SIB 52 10 25

THIRD SEAT ROW ELECTRIC BACKREST ACTUATOR DESIGN CHANGE

2025-08-19

| E-Series | Model Description |
|----------|----------------------------|
| G07 | X7 Sports Activity Vehicle |

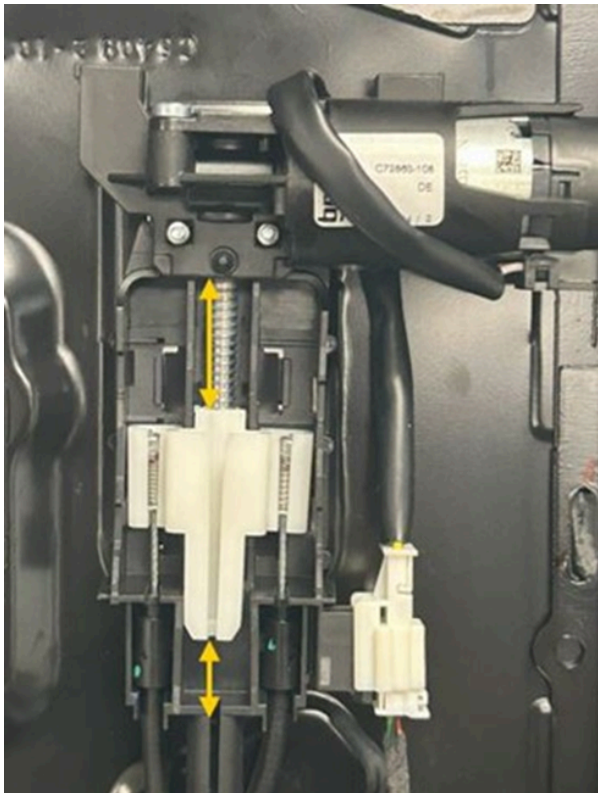
The electric actuator for the third row (3SR) seat changed design and part number, and is used in production vehicles as of March 28, 2025.

- There are two such actuators at this seat row, one for the left seating position; and one for the right

The new actuator’s spindle driver “turns in the opposite direction from the previous design,” thereby requiring a change/update of vehicle’s software.

This design improvement ensures the seat back latches and headrest will release even when the actuator is experiencing a low voltage condition.

The improved part fits vehicles of all production dates. The new actuator’s spindle driver turns in the opposite direction from the previous design, requiring a change in vehicle software.

- **52 20 9 473 697** Actuator folding backrest for vehicles **built prior to March 28, 2025** (part to be discontinued)
- **52 20 5 B6C 6A1** Actuator folding backrest for vehicles **built after March 28, 2025**.
 - When installing this improved actuator into a vehicle **built prior to March 28, 2025** you must **replace the headrest actuators in both the driver's and passenger's third-row seats at the same time AND perform ISTA/P conversion "Replace 3rd row actuator"**.
 - When installing this improved actuator into a vehicle **built after March 28, 2025** only **replace the defective side**
